ADA Curb Ramp New Construction Inspection Form (Parallel)

NW 307th

23885.56

Eggiman Ct

PARALLEL RAMP (PL)

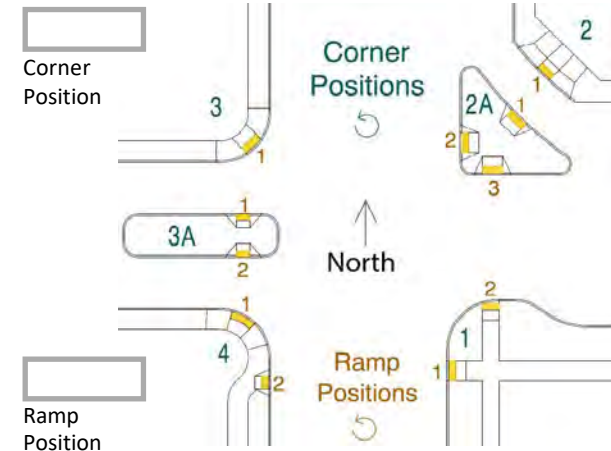
2.7 $\leq 2.0\%$ ☐ $> 2.0\%$ ☒

8.5 $\leq 8.3\%$ ☐ $> 8.3\%$ ☒

2.7 $\leq 2.0\%$ ☐ $> 2.0\%$ ☒

Comments:
Poor craftsmanship, RR2, IITD
